# ***Technical Service tip***

## ***Reduce fan noise***

***Reference no: Reduce fan noise***

D40:4L

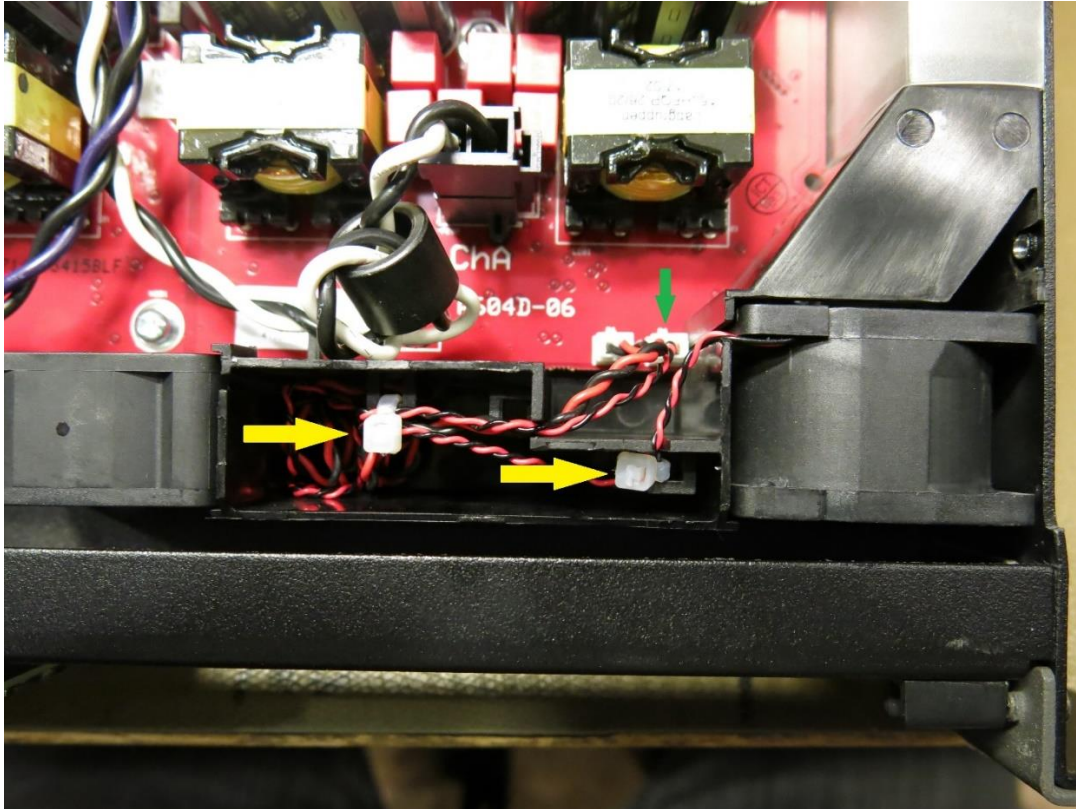
Replace the F40x28-24HS fan to F40x20-24SHS

Replacing the fan will reduce noise from the fan but cause a minor performance decrease in applications with 2,67 Ohm and lower loads due to the smaller cooling capabilities of the replacement fan.

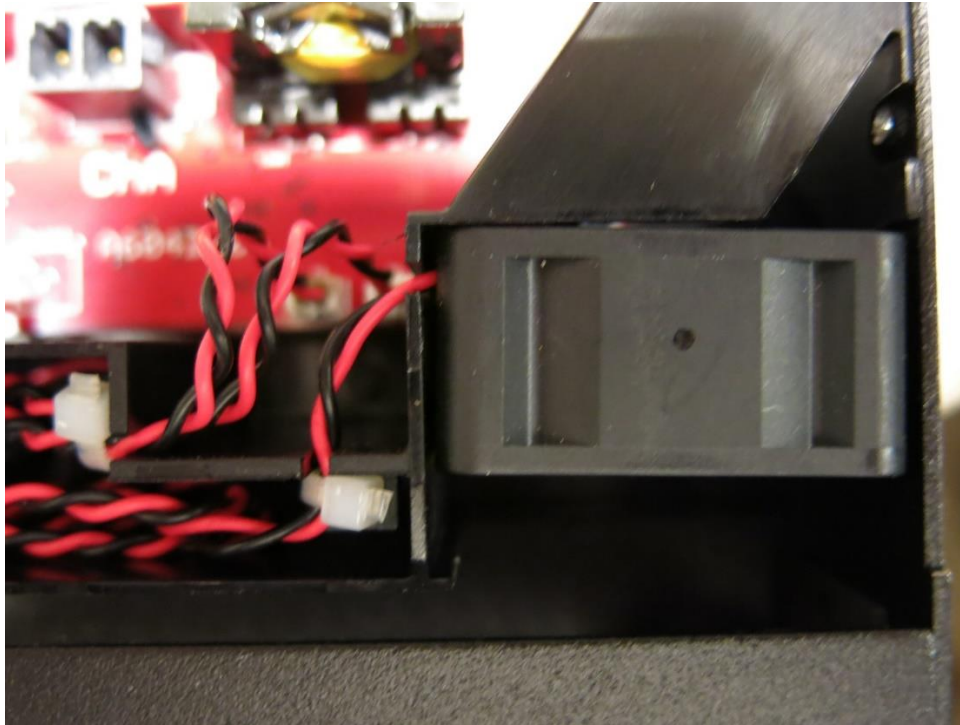
Cut the two cable strings (yellow arrows) and disconnect the fan from the connector (green arrow) and remove the fan

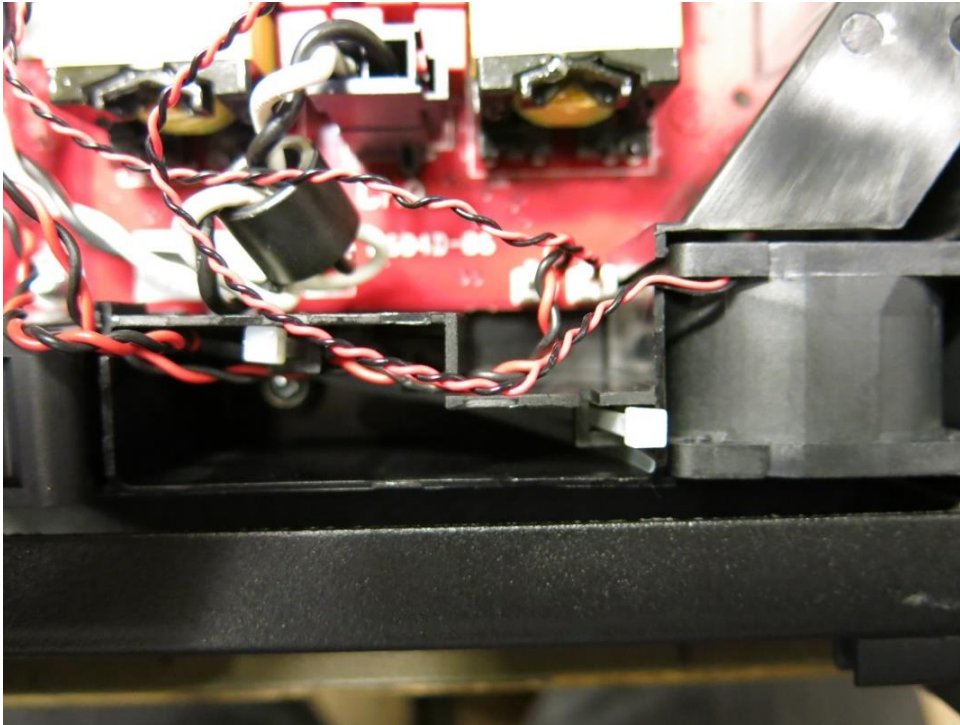
Mount the new fan and connect it to the board

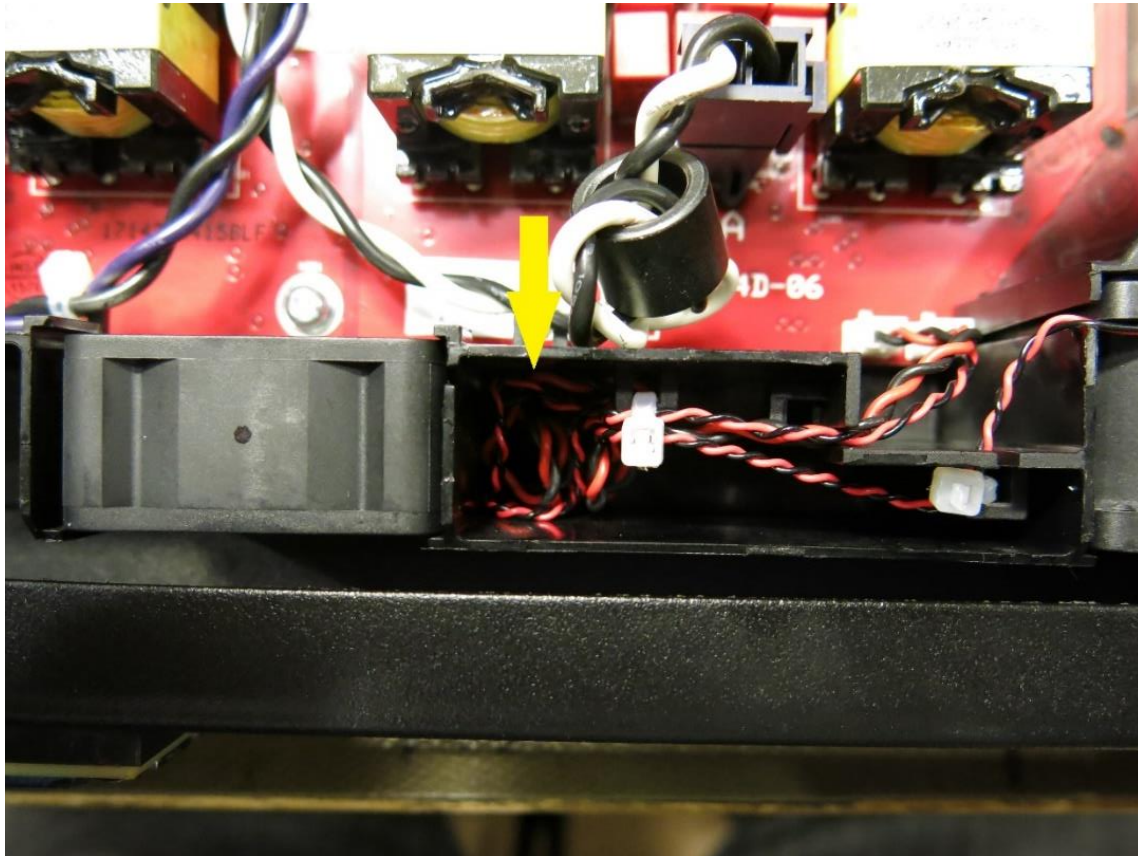
Mount two new cable ties like shown in the picture

Now place the cables like in the picture and tighten the cable strings  
Push down all excessive cable in to the fan holder like shown in the picture
